## CHAPTER 3 – REVISIONS, CLARIFICATIONS, AND CORRECTIONS TO THE DRAFT EIR

Harvard-Westlake River Park Project

**Figure II-6**  
Harvard-Westlake School Athletic and Recreational Facilities Conceptual Site Plan

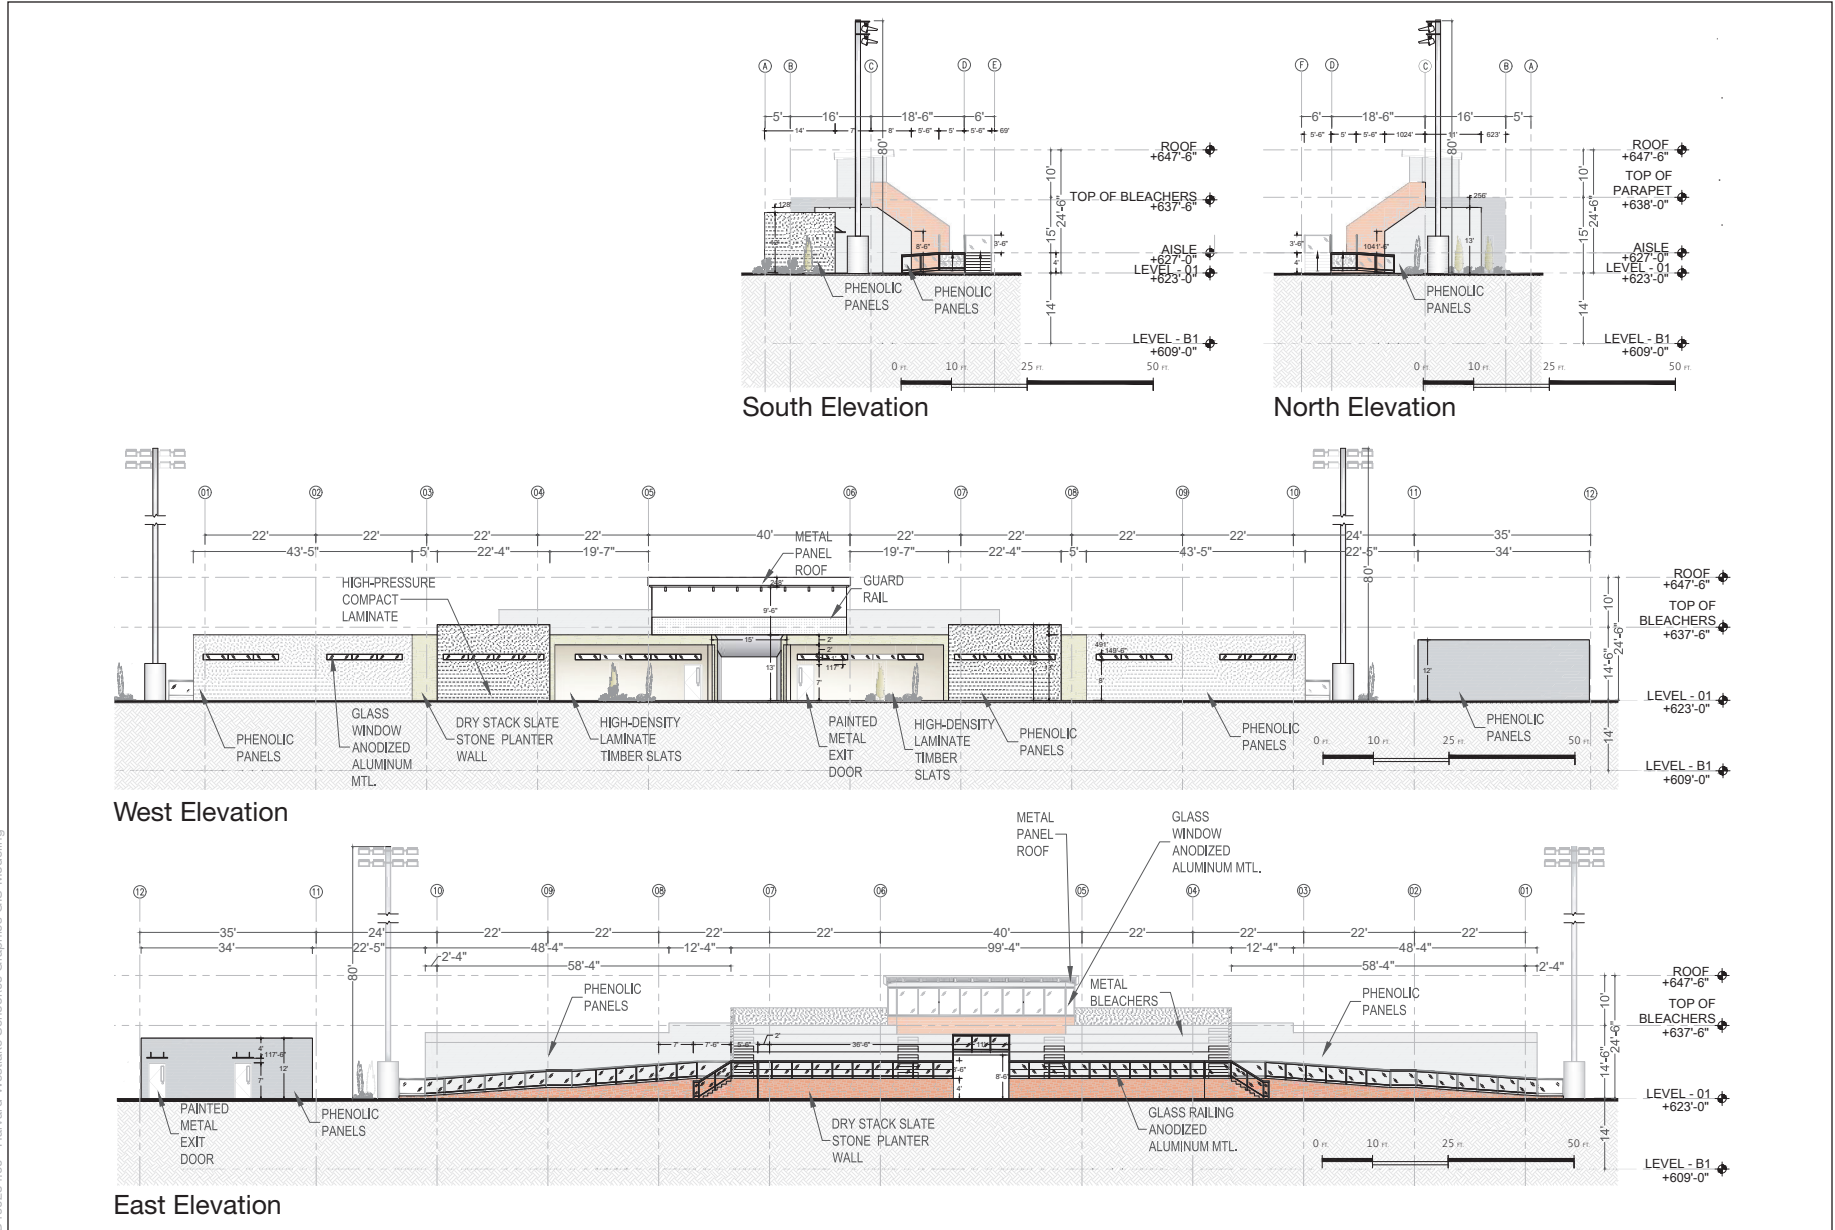
7. Page II-16, **Figure II-6**, *Harvard-Westlake School Athletic and Recreational Facilities Conceptual Site Plan*, is updated and modified to show the reduction in the surface parking lot, the change and reconfiguration of the swimming pool bleachers and canopy, removal of pool diving boards, removal of surface water features to the west of the gymnasium, removal of the “River Overlook”, removal of tennis elevator and stairs, and updated light pole quantities and locations.

**Figure II-8**  
Gymnasium Elevations – North and South Views

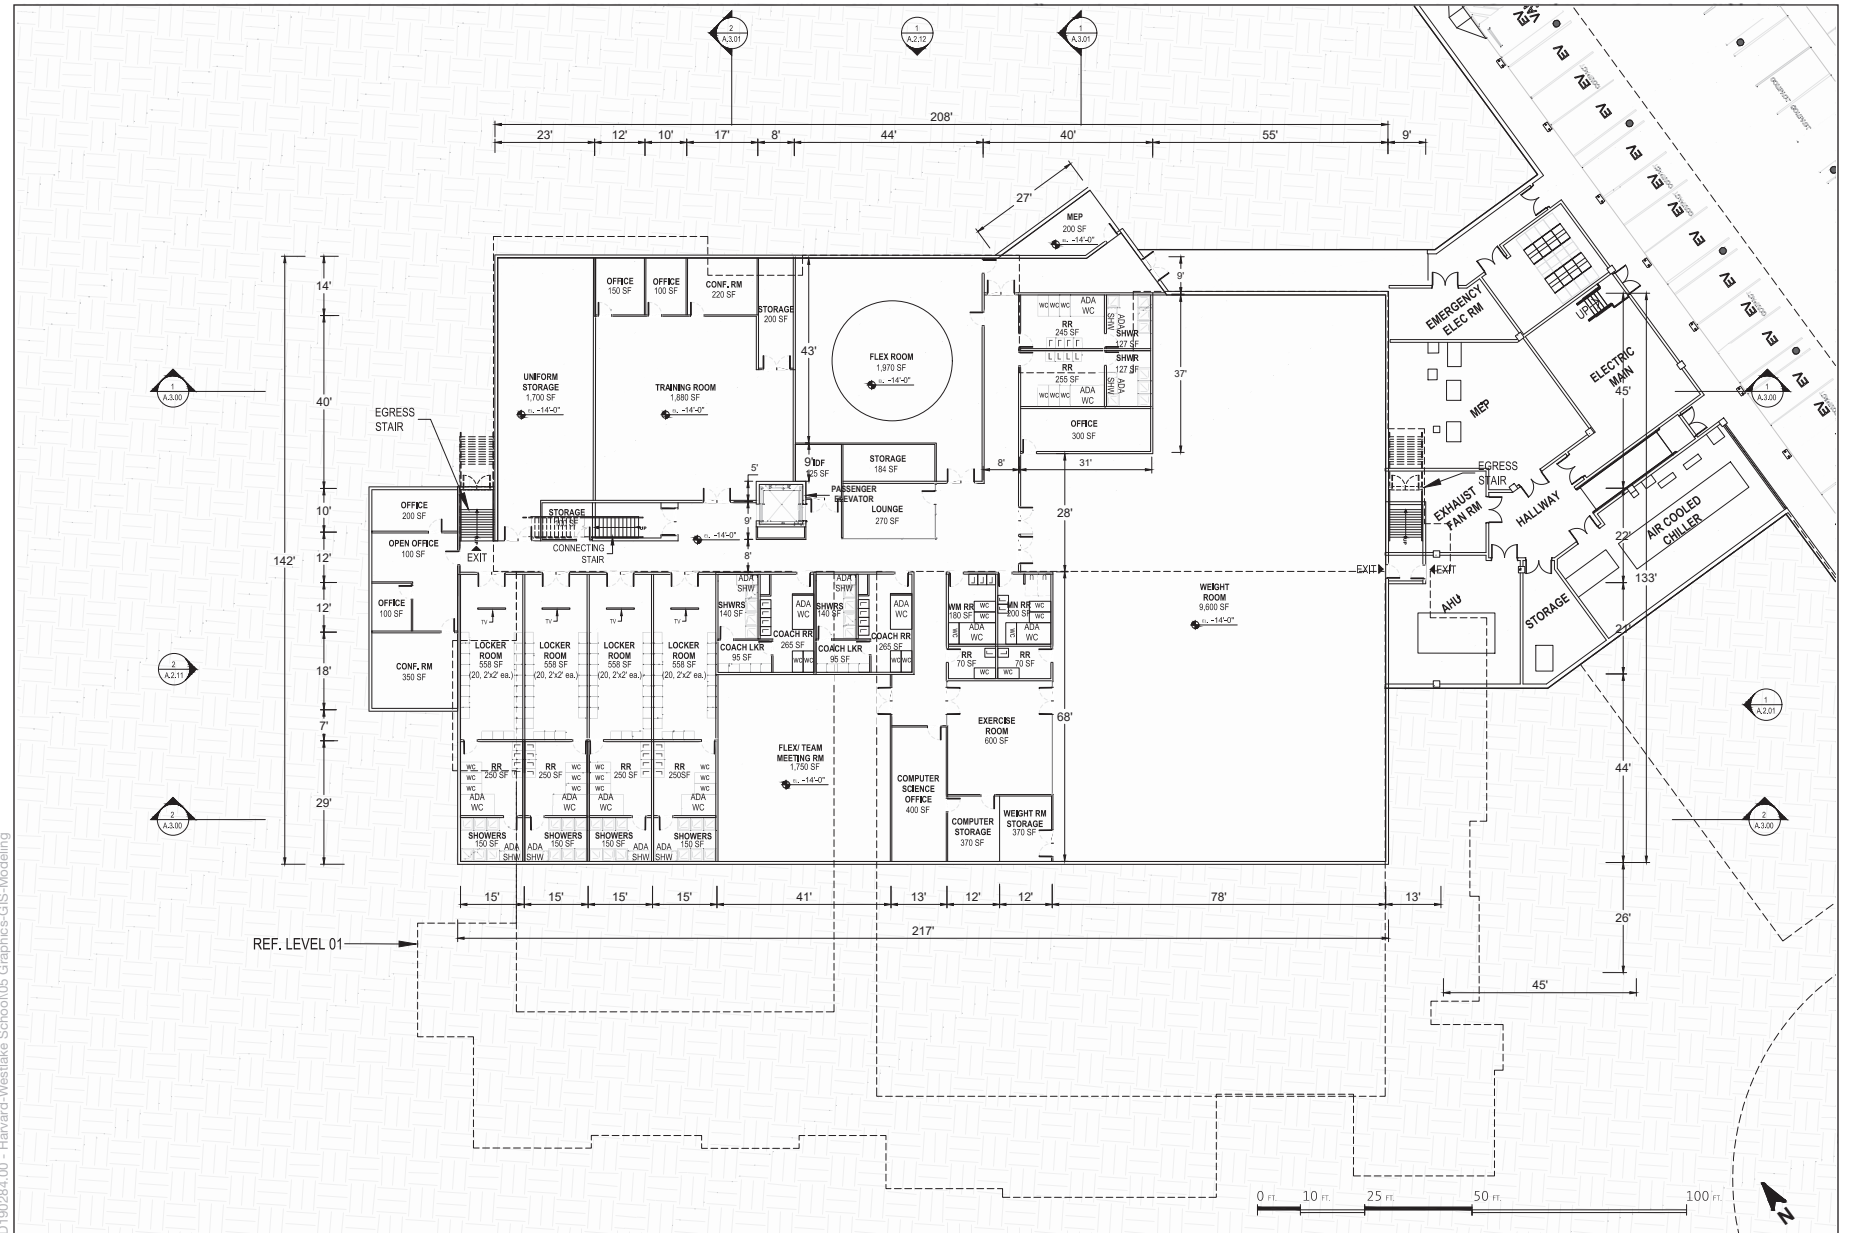
14. Page II-21, Figure II-8, *Gymnasium Elevations – North and South Views*, is updated to show that the window area on the south side of the gymnasium has been removed from the scope of the Project and will be converted to solid walls, and the window area of the north side of the gymnasium has been reduced in size.

**Figure II-10**  
Gymnasium Level 1

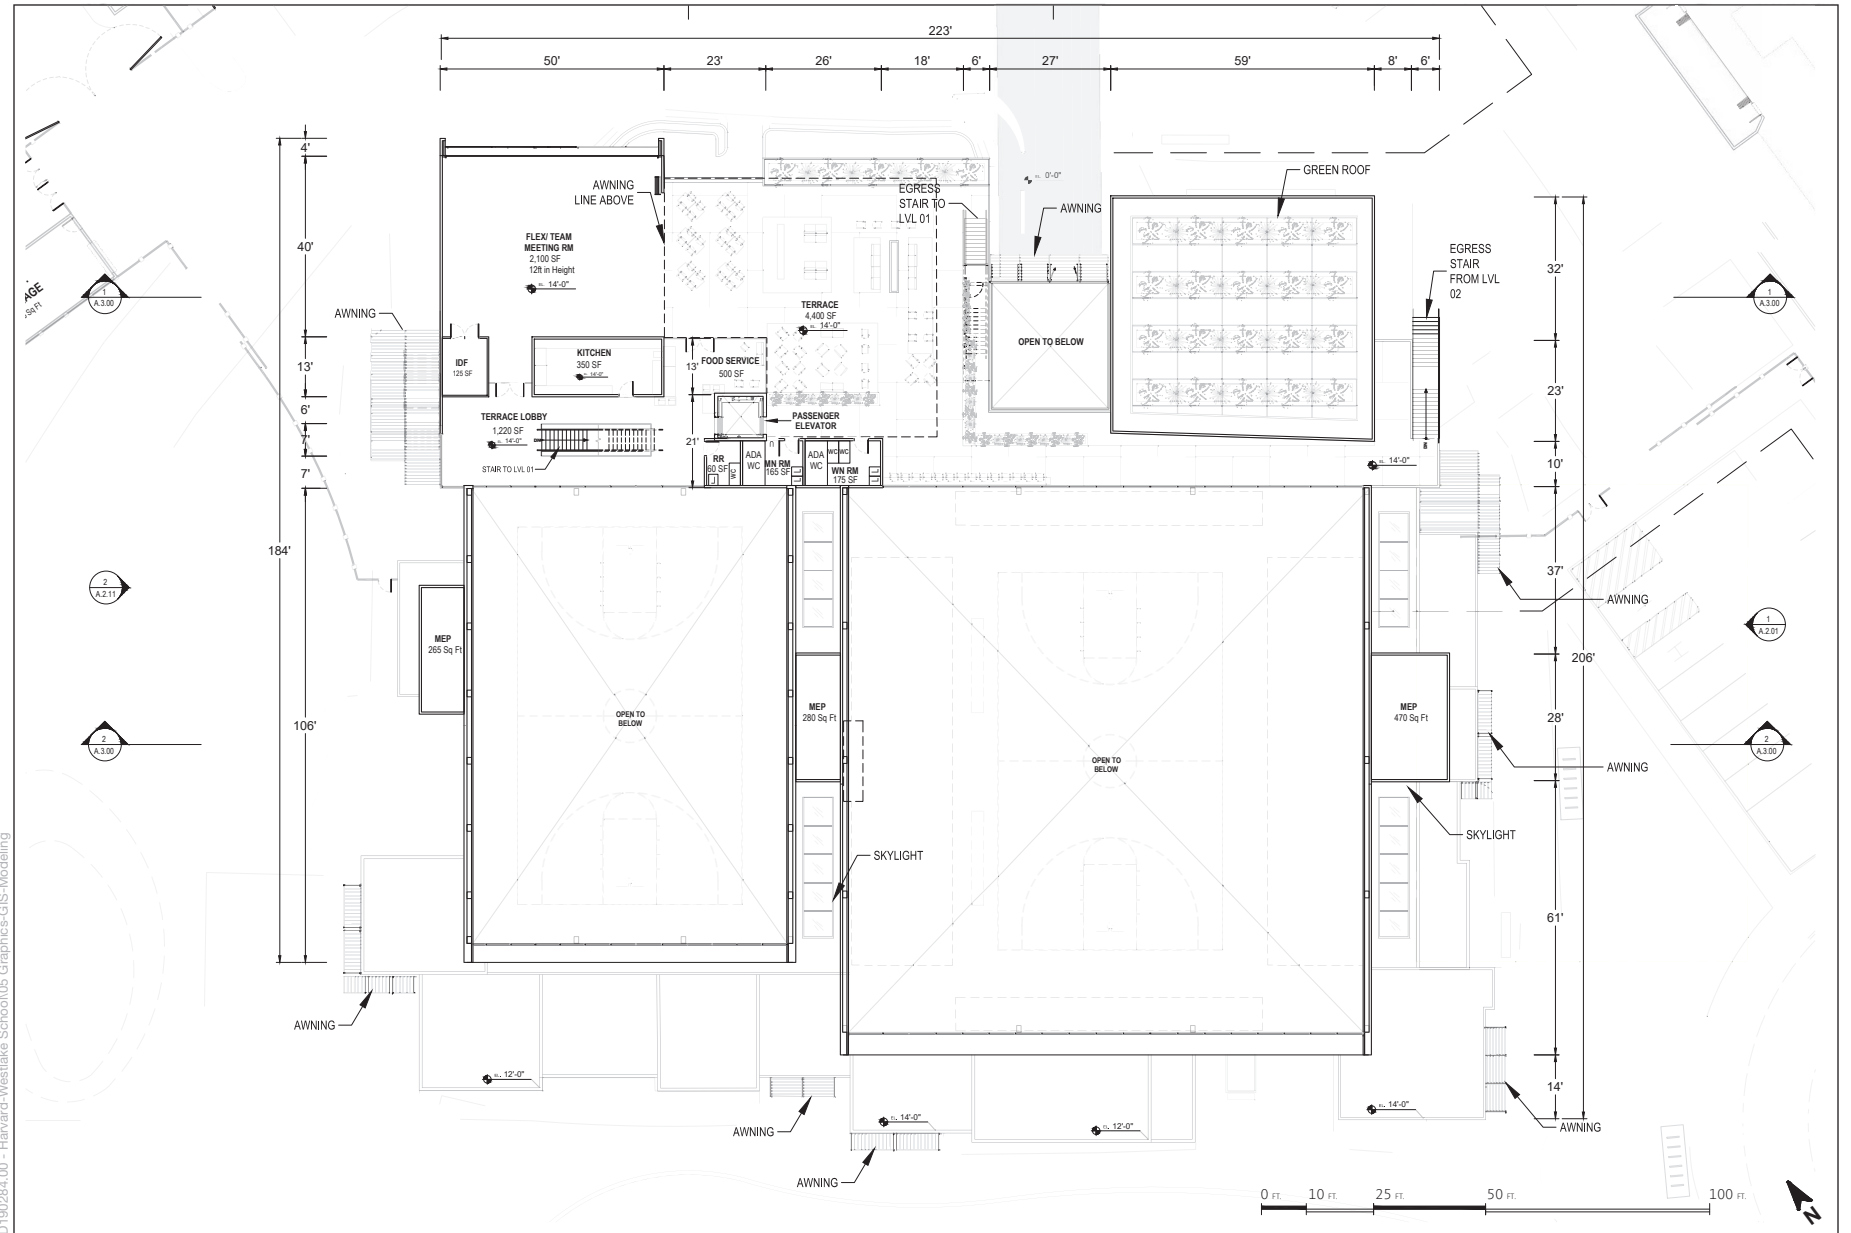
16. Page II-23, Figure II-10, *Gymnasium Level 1*, is updated to rename the “Flex/Team Meeting Room” to “River Room.” The updated figure also shows the reduced footprint of the parking structure adjacent to the gymnasium building and a revision to the number of Court A bleacher seats.
